**Subject:** Hemphill Diversion Project  
**Re:** Concept Design Change to Cone Screen

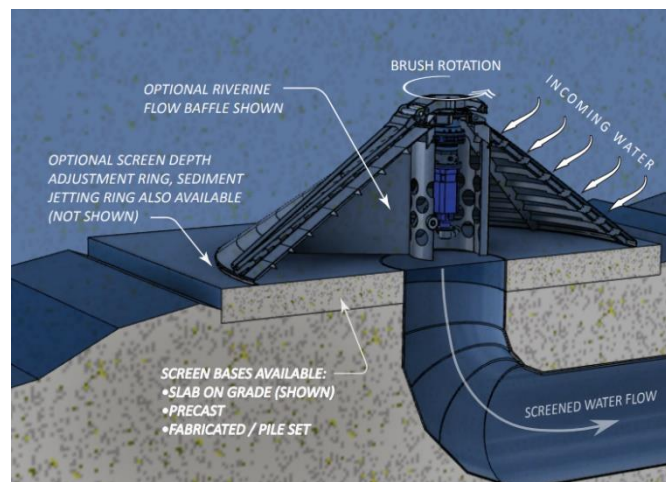
While we believe that the Farmer's Horizontal Fish Screen is an excellent solution for the Hemphill Canal that provides well researched protection of fish, minimal head loss, debris management, and a competitive cost, we understand that an extended design process would be necessary to establish design criteria for a horizontal screen system that would satisfy CDFW and NMFS. Given the short timeline to complete design, we have revisited the alternatives that were considered in the CDR and recommend that design continue with a cone screen (see image below) manufactured to meet current CDFW and NMFS design criteria for an active screen.

The current concept is for one 78" diameter by 21" tall cone screen with an automatic brush cleaning mechanism. A screen of this size would allow up to 12 cfs to be diverted. This screen would provide Nevada Irrigation District (NID) with the flexibility to increase deliveries in the future. However, if demand on Hemphill Canal increases beyond 12 cfs, a second screen would be required. As currently drawn, a larger intake structure would be installed which would allow for the addition of a second screen in the future. Current design includes stop logs that would allow for the dewatering of the screen as well as a divider wall allowing for the cone screens to operate independently of one another.
